City of Richmond Planning and Development Department

Report to Committee
To Planning - NOU-16, 2000

RZ 07-380219

Application by Toyu Group Holdings Ltd. for Rezoning at 7751,

Attachment 4: Preliminary Architectural Drawings

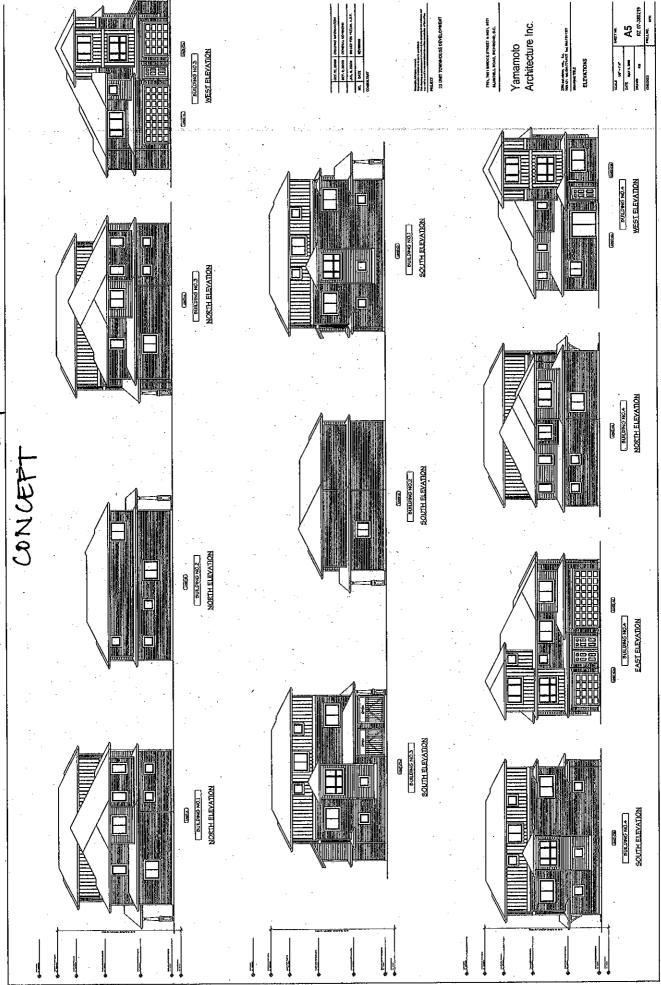
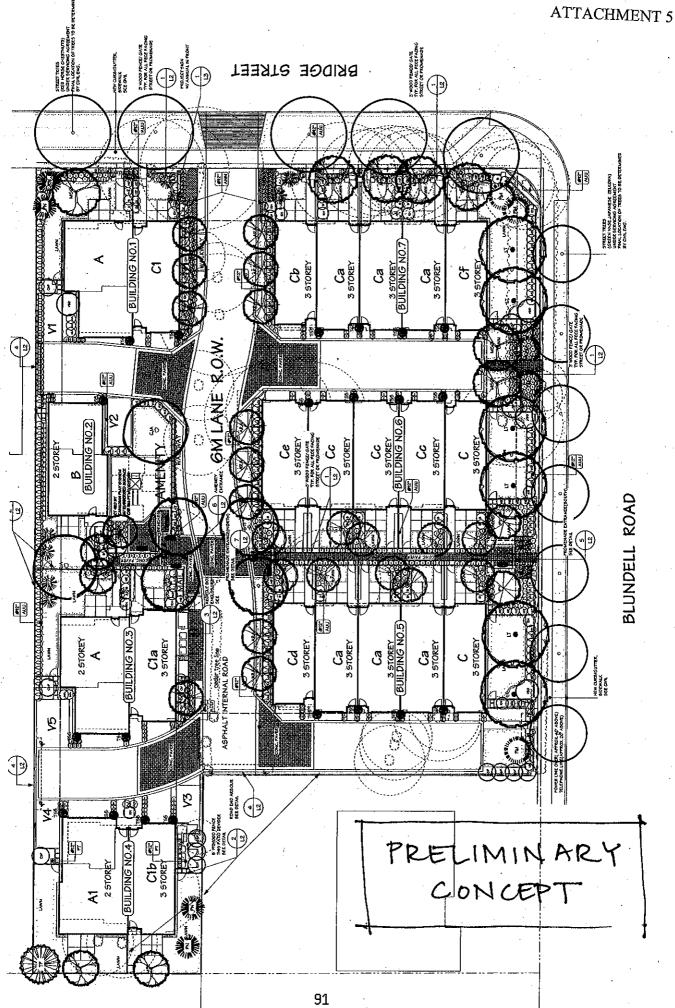
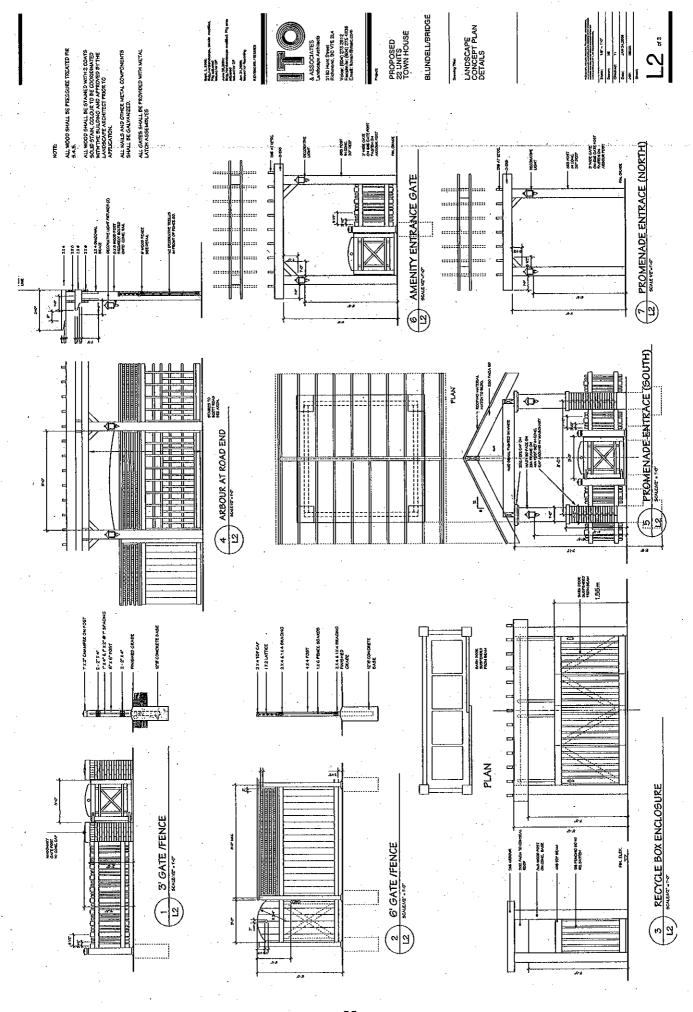
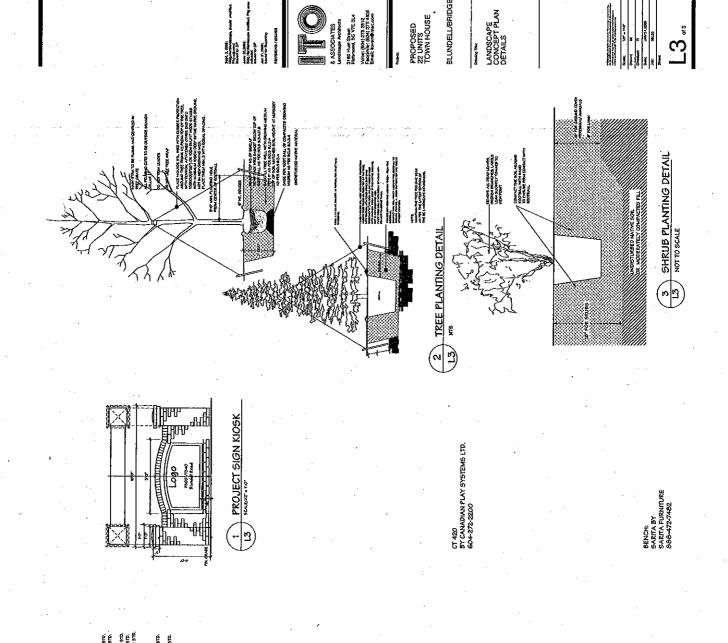
- two-storey unit A could be easily converted into an adaptable unit;
- try to locate accessible visitor parking close to the adaptable unit;
- consider increasing diversity in plant species to be used in landscaping (ex. Magnolias);

- pedestrian safety needs to be addressed in view of the public lane;
- differentiation is needed between public and private space;
- The typology seems to want to be row-housing instead of a larger mansion and back lane carriage housing. Try to reinforce the unit identities as individualized and separate;

- difficult project to conquer. The general form and arrangement of blocks is appropriate. The lane is a challenge. Concerned about children running to amenity area across lane. Lane needs traffic calming. Either step down massing south of amenity area or move it for sunlight penetration;

- 'prairie style' is not convincing because of the building height and lack of overhangs; the building should be broken down into manageable pieces. Look at English rowhouses;

- entrances to buildings are too small considering the size of the buildings;
- buildings 1 and 2 on the north side can be rotated at 90 degrees so that a series of private drive aisles and building and garage entrances will be bisected by the public lane to preclude interference between the lane and unit entries;

- the "tower" element that appears in two units may be more appropriate at the corner;
- brick entry from Bridge Street may not serve any purpose, does not mark private entry and can be dispensed with;

- reconsider the Blundell pedestrian entry. Nice structure, but location seems arbitrary;
- streetscape yards and frontage are good. Materials and colours to bring variety; and

- a pedestrian mews connected to Blundell instead of back yards would be more appealing.

- he does not have the same level of concern about the units fronting a public lane. Recesses and well-defined entries to the units would be necessary for pedestrian safety. There is no pedestrian access except through the public lane.
- narrowing the lane or placing bulges on both ends of the lane could be considered to slow down traffic. Or the lane could be stopped mid-block to stop through-traffic.

- turning the north units to extend the drive aisles across the lane would solve the lane interface issue, but would also likely result in a loss of units. Consider reducing the North setback to 1.2 m, reducing the Blundell setback, or shifting the lane to regain some units.
- the security of the lane could be addressed with a private look, making it inconvenient for non-residents.

- 1. consider providing the opportunity of converting unit A into an accessible unit *Incorporated in buildings 1 & 3*;
- 2. ensure that handicapped parking is near the adaptable unit *Incorporated. Accessible* parking space is located near building 3;
- 3. consider increasing the species diversity of the landscaping Will incorporate through the Development Permit design;
- 4. consider pedestrian circulation on the public lane *Incorporated. Walkway provided north* of the lane;
- 5. consider an alternative to the public lane for access to units along the north side Resolved.

Building orientation changed as suggested, resolving interface issue;
- 6. consider providing some separation between the public and private grounds in the lane area Resolved. Building orientation changed, resolving interface issue;

- 7. consider defining the units, especially those fronting the public lane area, as having a "coach house" style rather than a "large house" style Resolved. Building orientation and typology changed, so that no units are fronting the lane;

- 8. consider lower massing at 2-storey volume near the amenity space Incorporated;
- 9. consider providing some site signage and identity for the front entry *Incorporated*;

- 10. consider breaking down the massing into lower divisions to achieve a more "row-house" pattern *Incorporated*;
- 11. consider the observation that the "tower" element that appears in 2 units to be more appropriate on a corner —Two and three storey duplexes along north of site prove a transition from lower single-family homes and taller townhouses;

- 12. consider extending the format of the south side of the site to the north Incorporated; and
 - 13. consider that the pedestrian entry structure from Blundell Road to drive aisle may not be valuable Entry structure aligns with pedestrian walkway and entries for buildings 5 & 6.
